# SONY® Service Bulletin

NO: ME3-99-003

**SUBJECT: MECHANICAL DECK GETS LOCKED**

**MODEL (S): MDX-61**

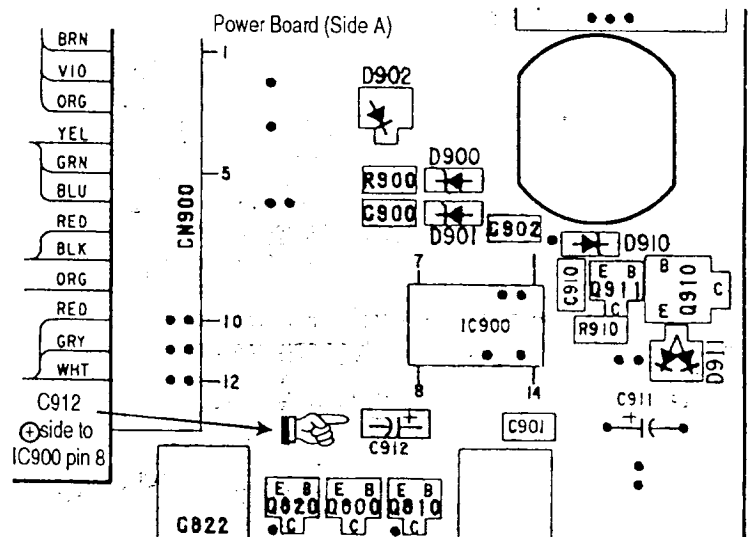
Apply the following changes on the Main Board.

- Replace IC600 CXP84340-043 with CXP84648-005 (8-752-882-95)
- Remove R616.
- Add R635 0 Ω Metal Chip (1-216-295-11).
- Remove R636.
- Add D603 MA728 (8-719-421-27).

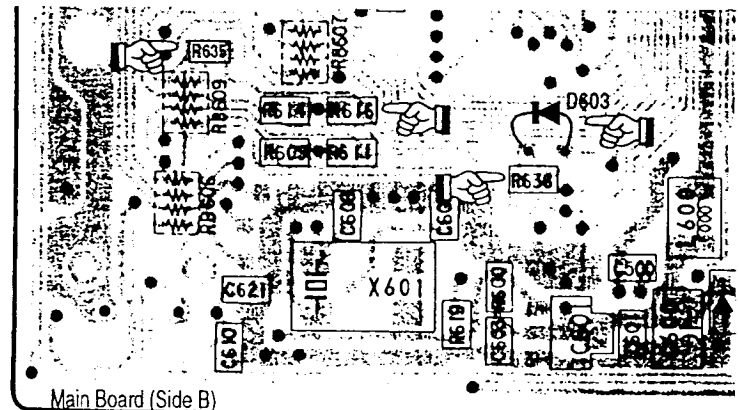
Apply the following changes on the Power Board.

- Remove C909.
- Add C912 2.2μF 10V Tantalum (1-135-149-21).  
Two versions of Power Board exist, one with and one without solder lands for C912.  
Mount C912 at the mounting location of C909 if no separate solder lands are available.
